Well Name: JICARILLA APACHE B	Well Location: T24N / R5W / SEC 20 / NESW / 36.296344 / -107.386384	County or Parish/State: RIO ARRIBA / NM
Well Number: 22	Type of Well: CONVENTIONAL GAS WELL	Allottee or Tribe Name: JICARILLA APACHE
Lease Number: JIC11	Unit or CA Name:	Unit or CA Number:
US Well Number: 3003927728	Well Status: Producing Gas Well	Operator: DJR OPERATING LLC

Notice of Intent

Plug and Abandonment Procedure
for
DJR Operating, LLC
Jicarilla Apache B 22
API # 30-039-27728
NE/SW, Unit K, Sec. 20, T24N, R5W
Rio Arriba County, NM

CONDITIONS OF APPROVAL

DJR Operating, LLC
Proposed Wellbore Diagram
Jicarilla Apache B 22
 API # 30-039-27728
 NE/SW, Unit K, Sec 20, T24N, R5W
 Rio Arriba County, NM

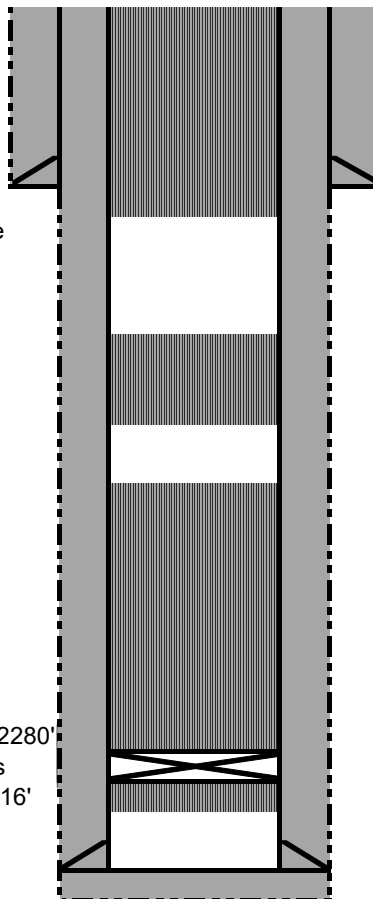
You are also required to place cement excesses per 4.2 and 4.4 of the attached General Requirements.
